ADDENDUM NO. 2

Smoky Row Elementary School Additions and Renovations

Project No. 222033.00

January 14, 2026

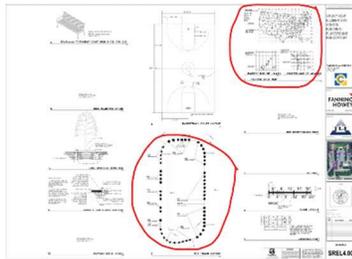
Question: I do not see the circled details on playground site plans for Cherry Tree Elementary.

I do not see the circled details on playground site plans for Smoky Row Elementary.

Please confirm if the circled pavement markings for both locations are needed or not.

Response: The provide details are to be retrofitted to fit the site conditions – provided extra details in case owner decides to install these pavement markings within ex. spaces.

A3.02

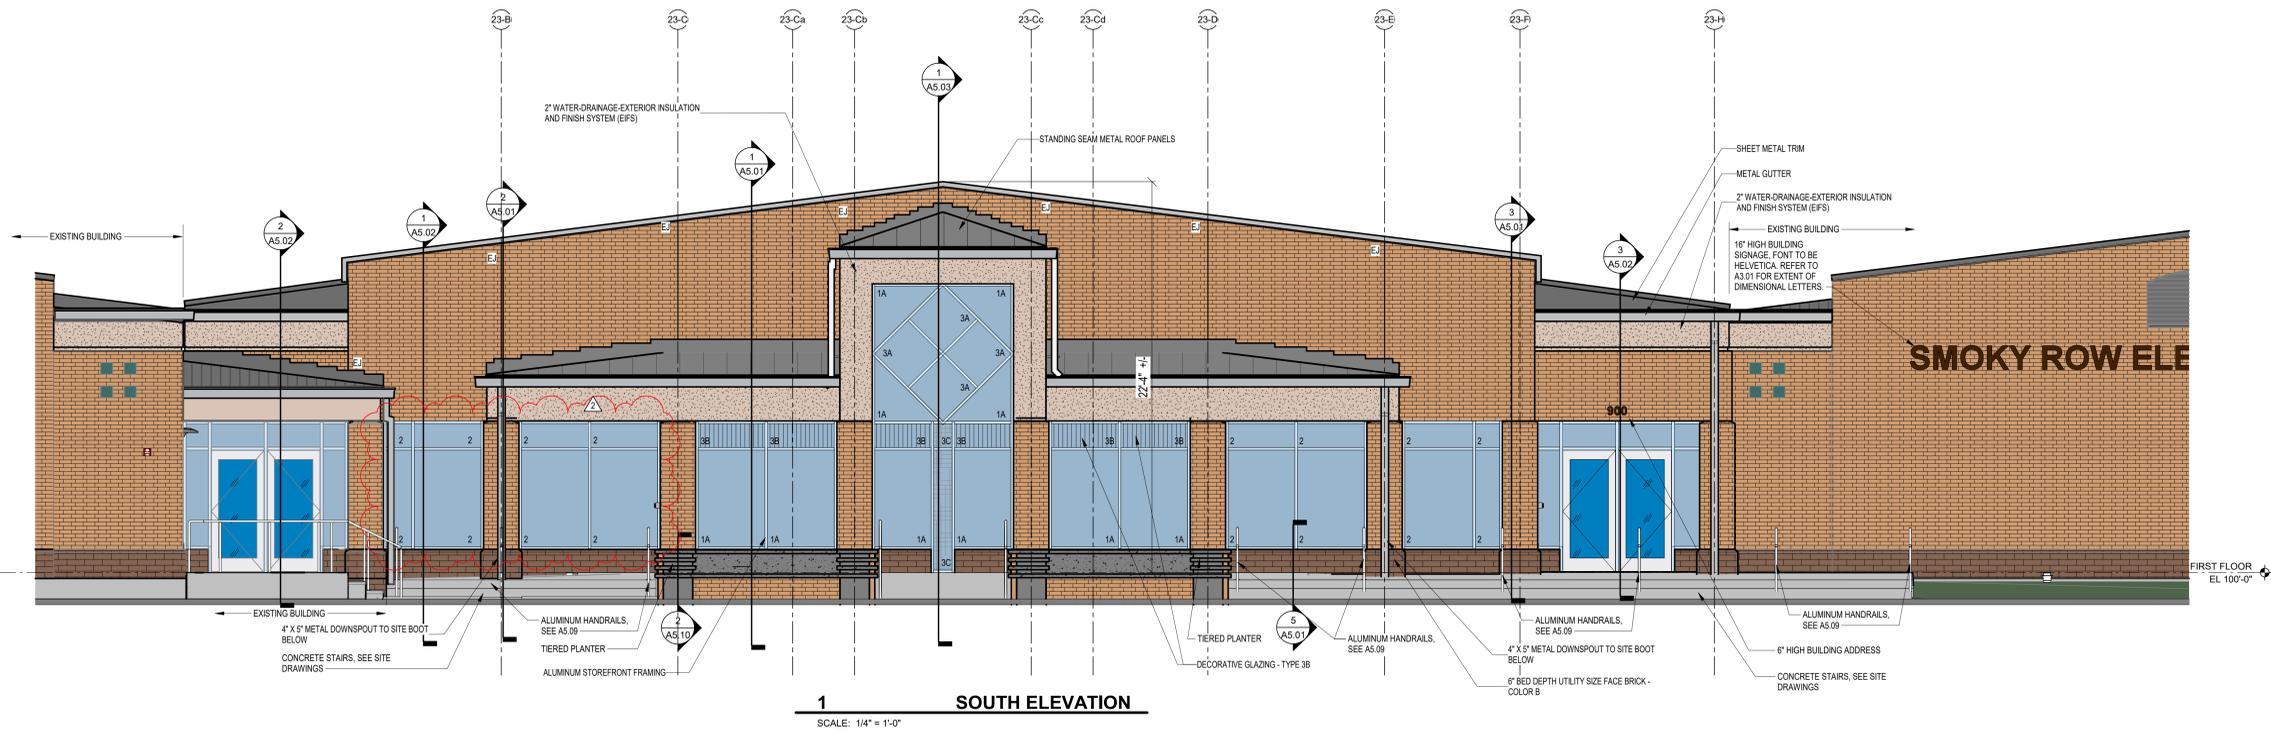
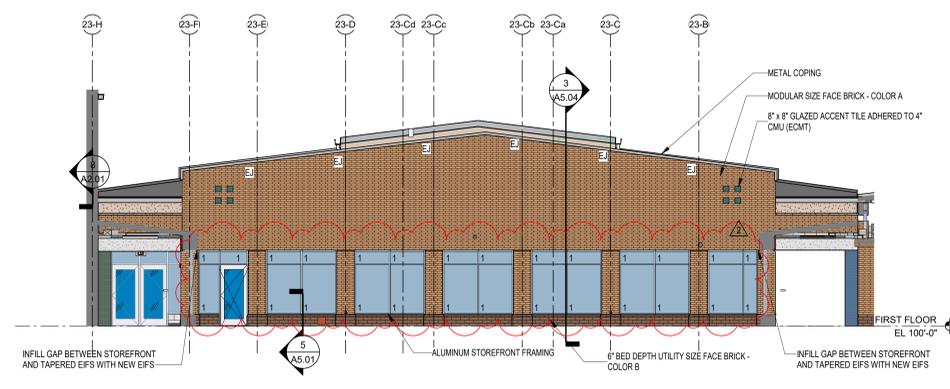
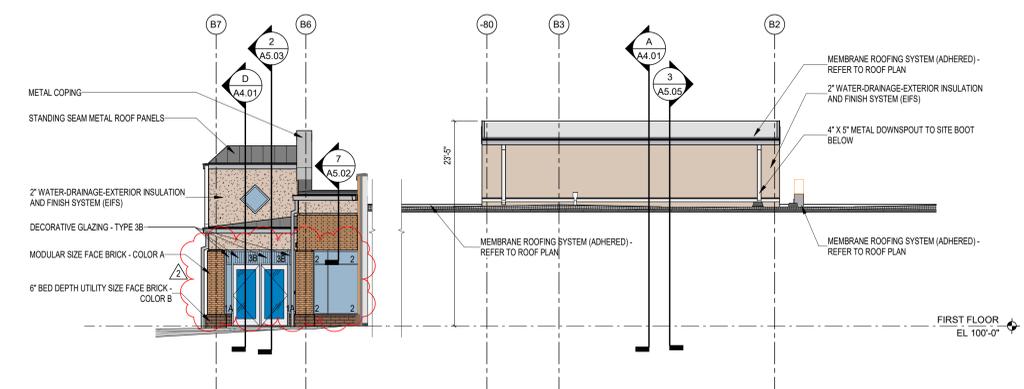
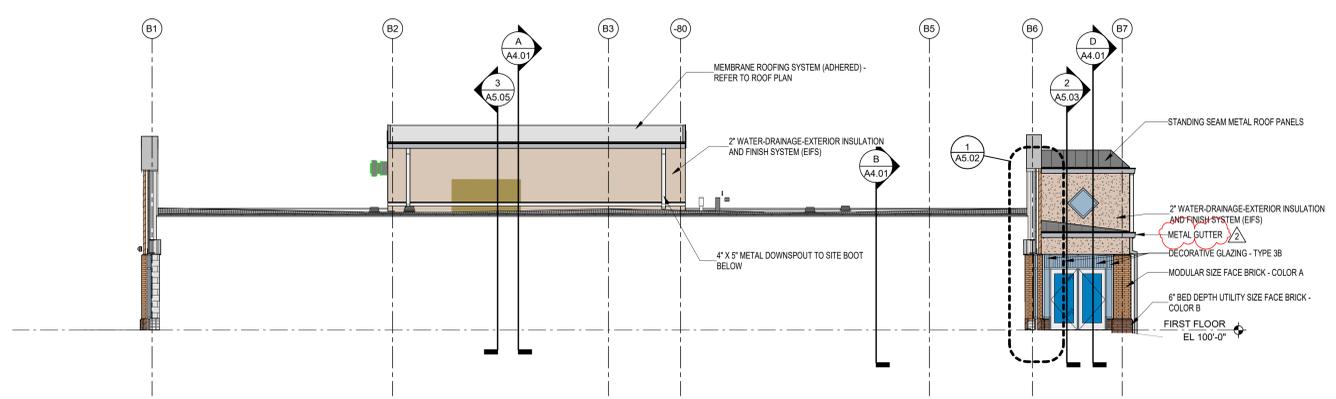
Question: None of the elevation on A6.01 show the glass type. I know from experience at Cherry Tree where some of the decorative glass will go. I can also see notes on the floor plan showing security glass. A6.01 needs updated showing the location of the glass types.

Question: Sheet A3.02 calls out glass types for the South front elevation, but none of the other elevations are called out. Can we get clarification on sheet A6.01? Also, we will need to know where the security glass needs to be located. None of the drawings show this.

Response: Elevation Sheet A3.02 clearly shows the glazing types for the front elevation, along with notes on the floor plan. All specialty glazing should be identified.

E2.01

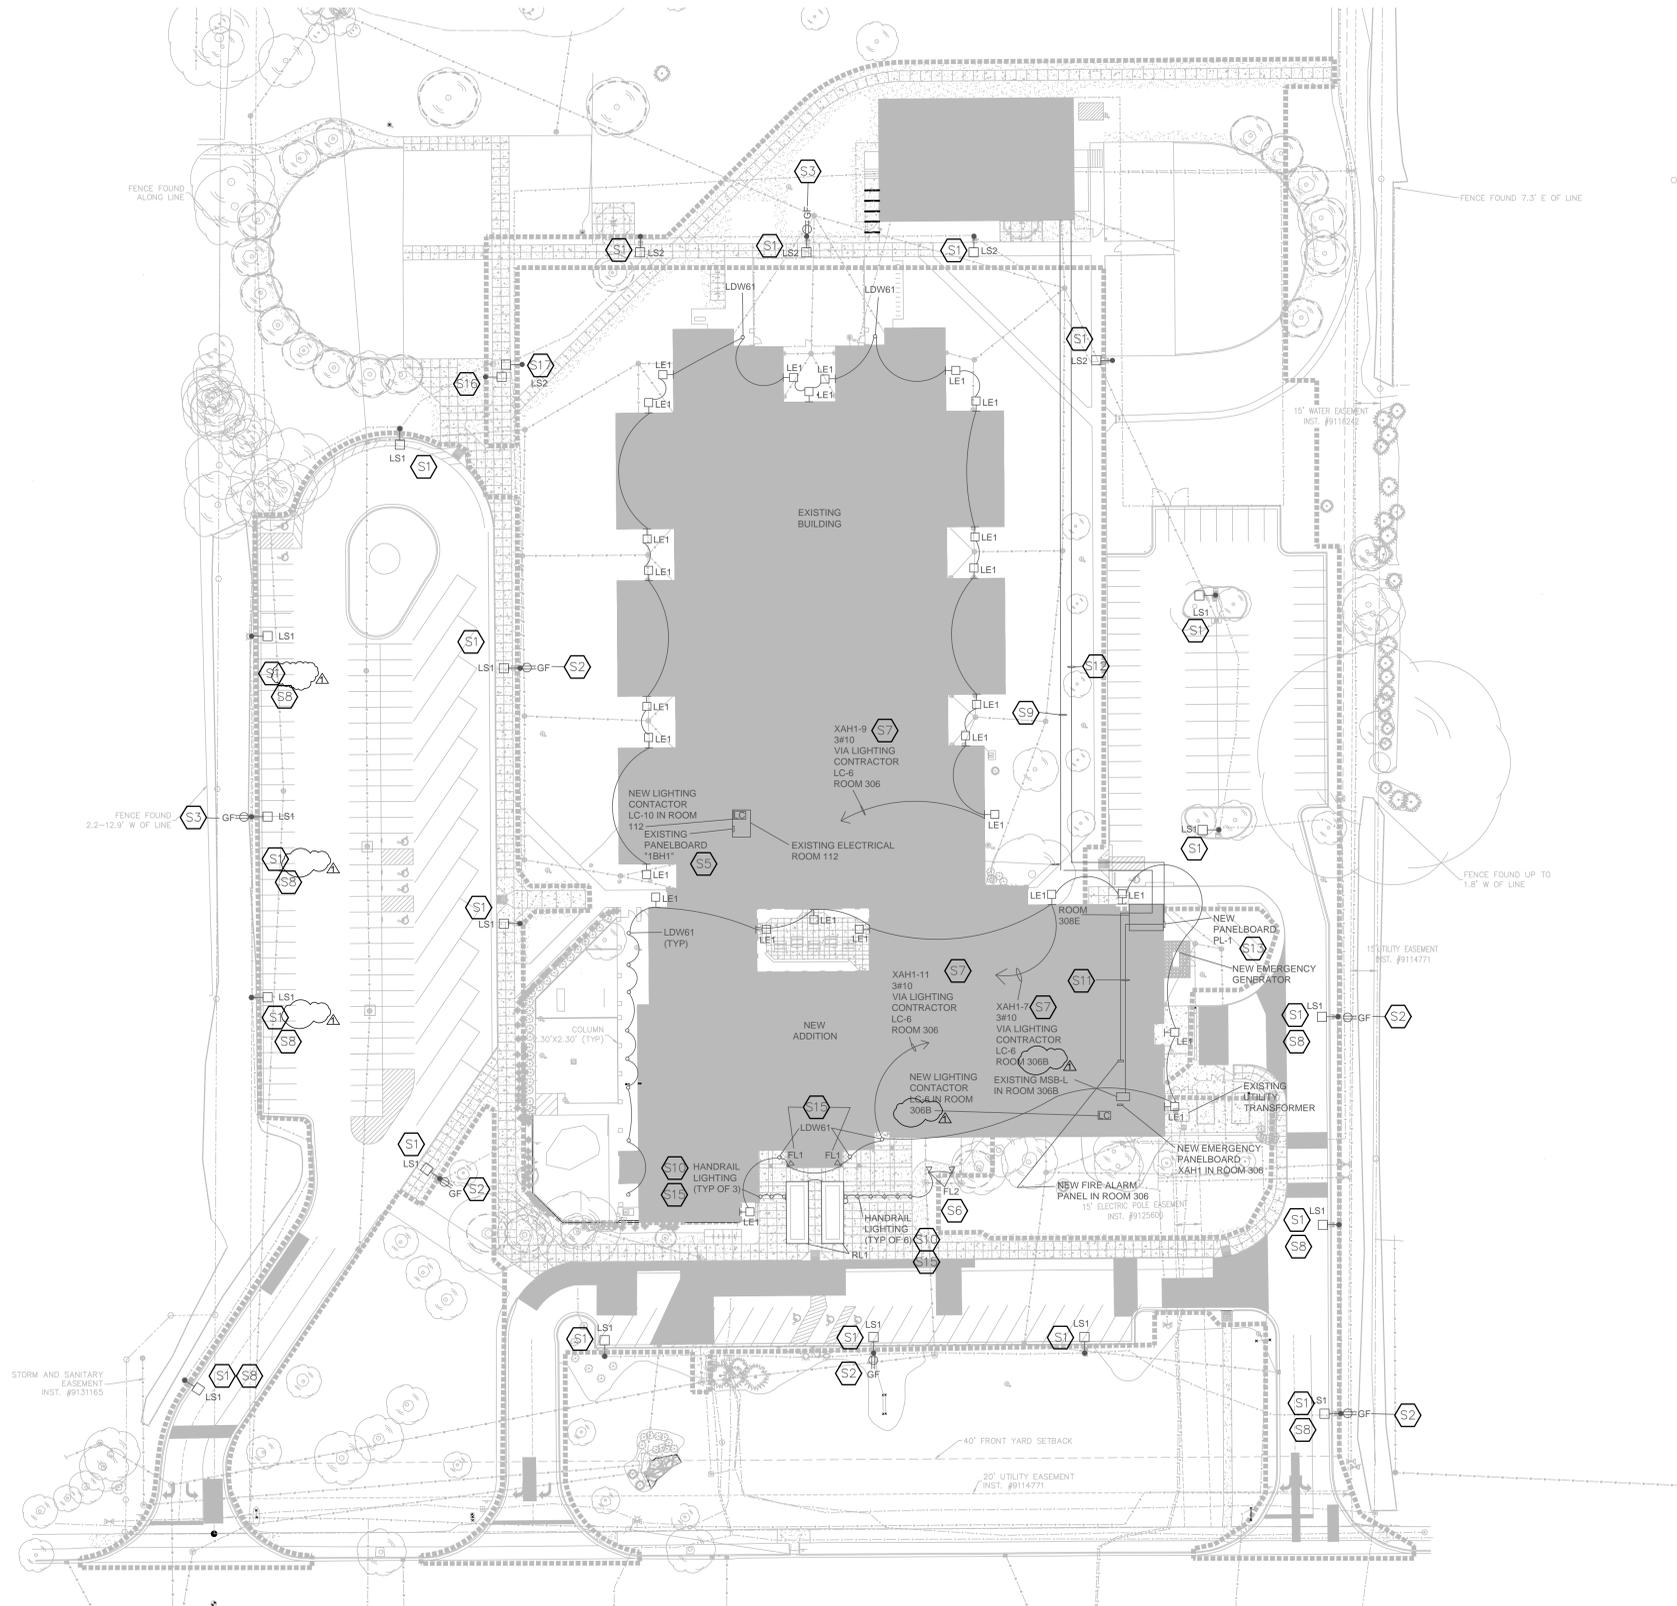
Question: E2.01 vs T4.01: East (2) LS1 differ in symbols as single vs double head. Which is correct?

Question: E2.01 vs E4.01: Location of LC-10. Please confirm location.

Response: Sheet E2.01 is correct. Single head.

Response: Room 306B. Will be changed in addendum #2.

E4.02

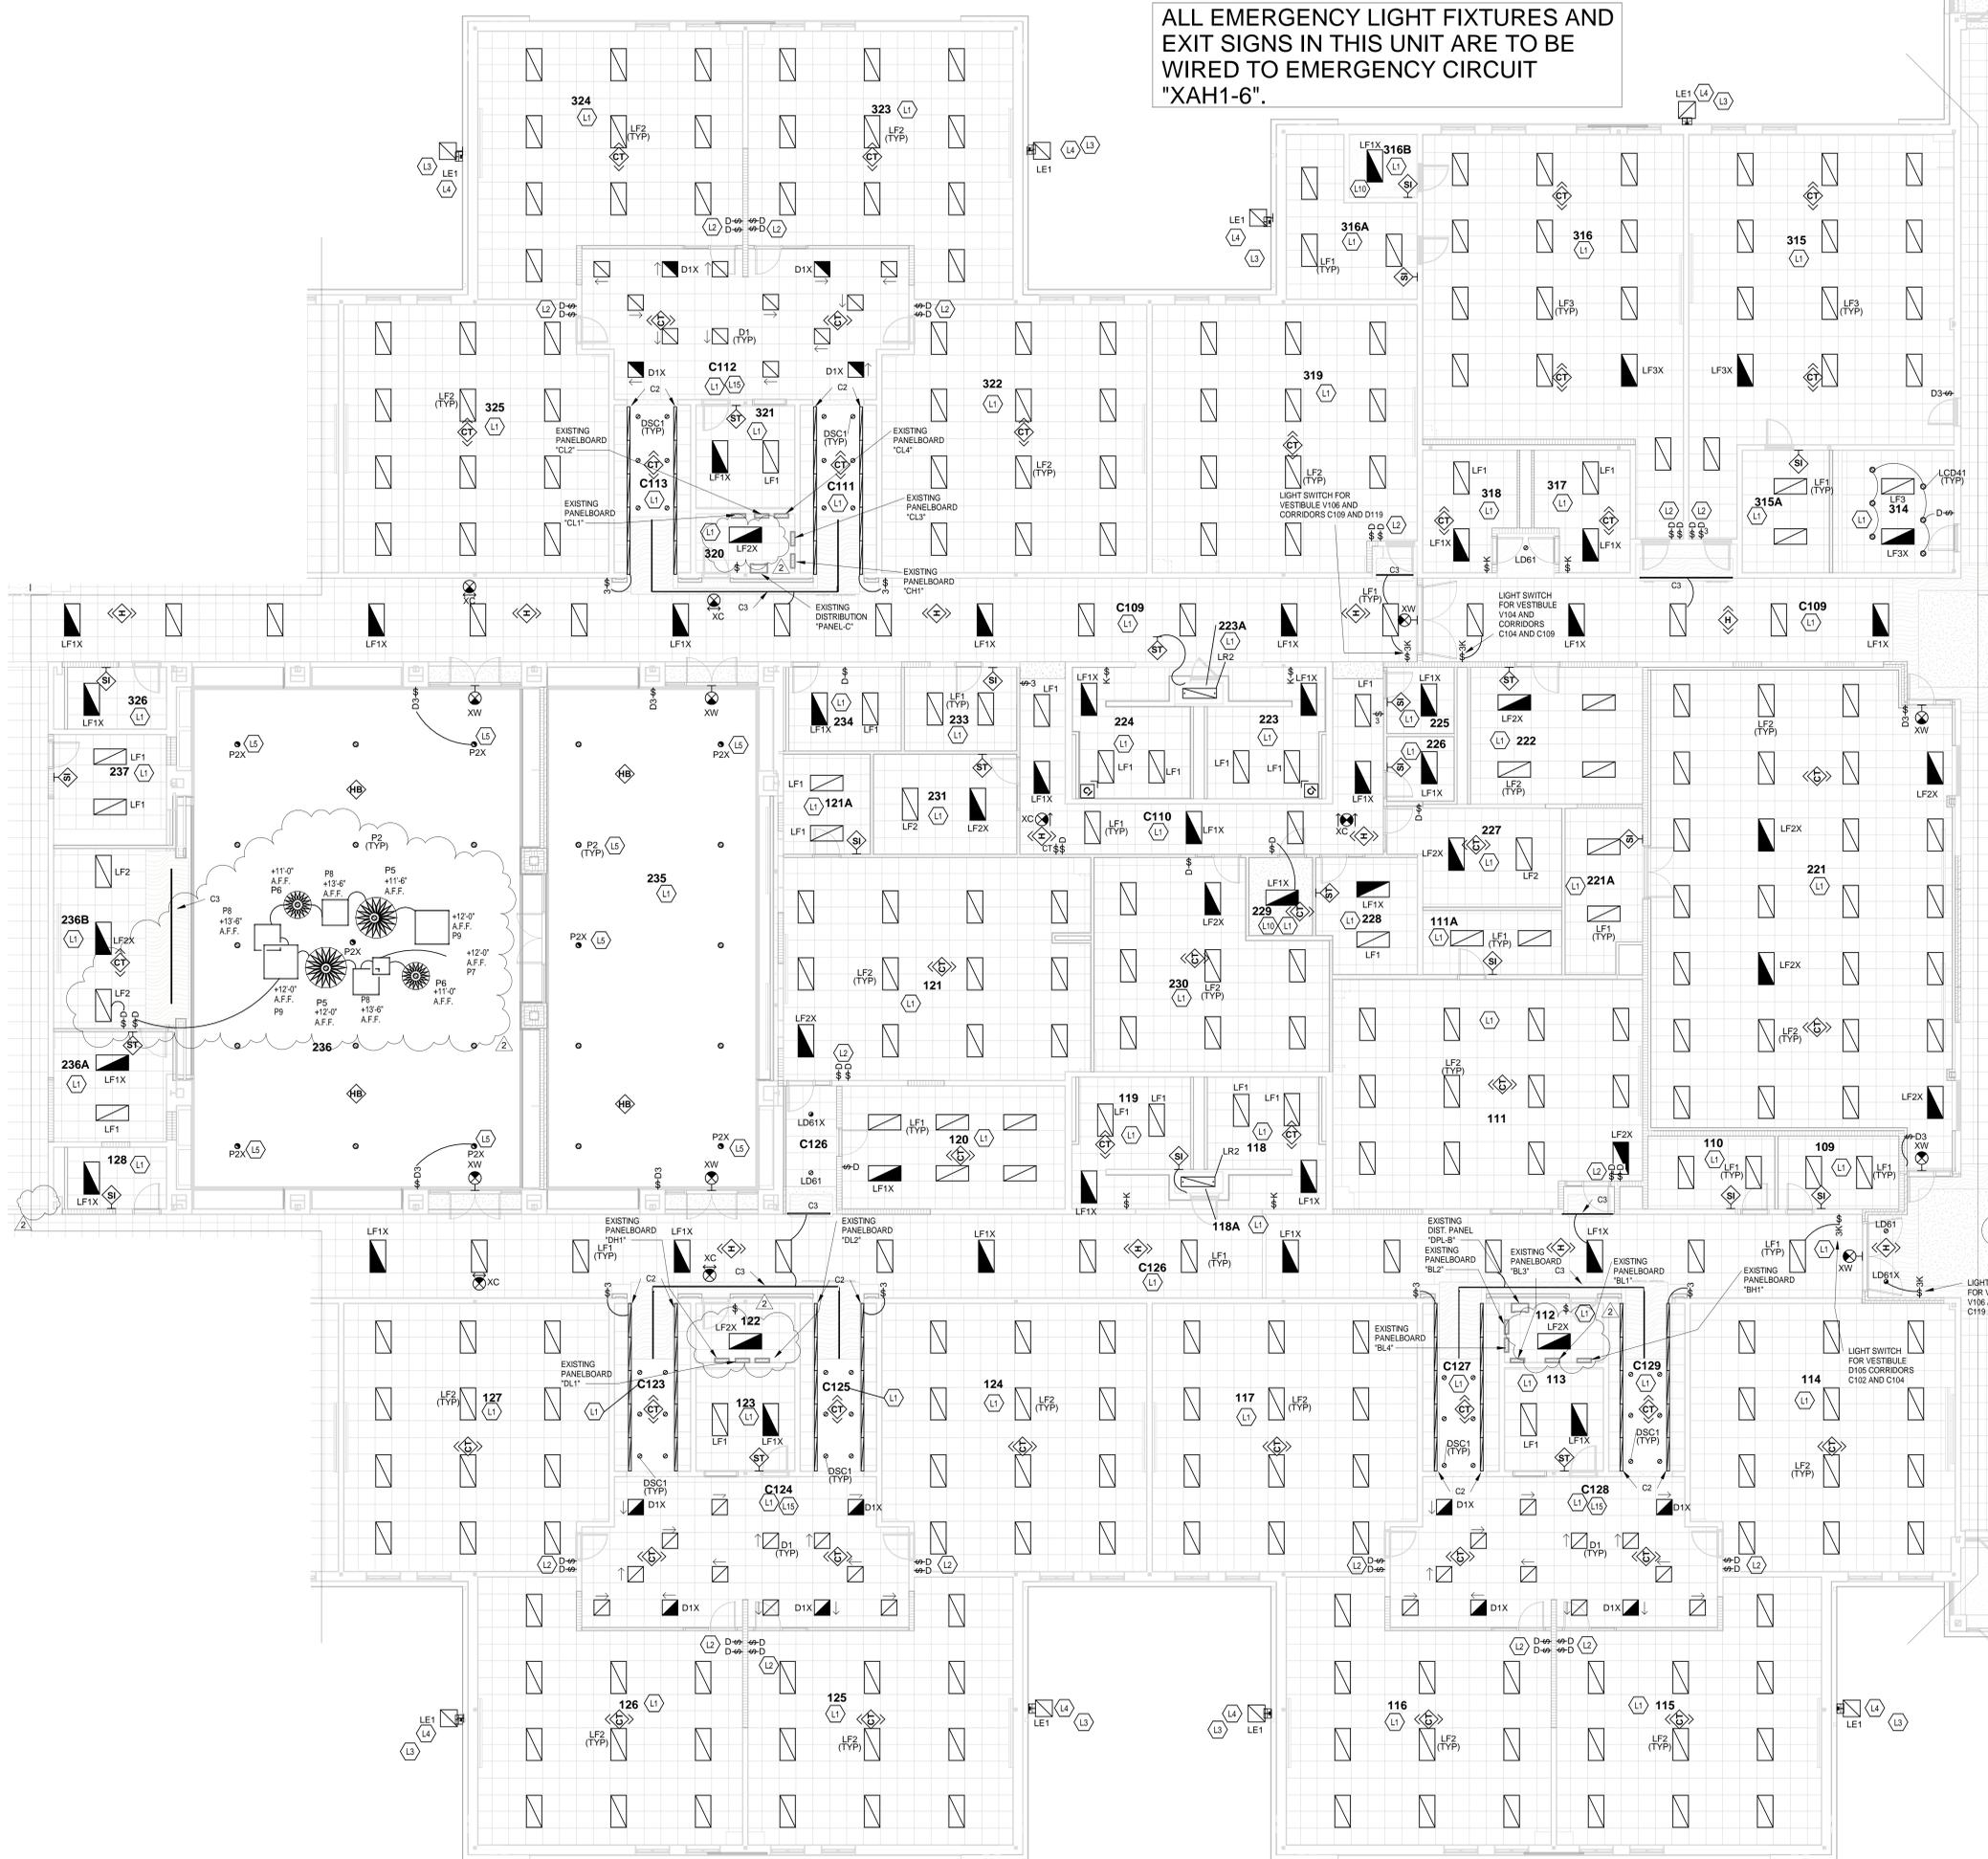
Question: E4.02: Rm 101 no OS CT's shown?

Question: E4.02: Corr C101 should this be a 3W Keyed Switch on south wall?

Response: Will be added in addendum #2.

Response: Yes. Will be changed in addendum #2.
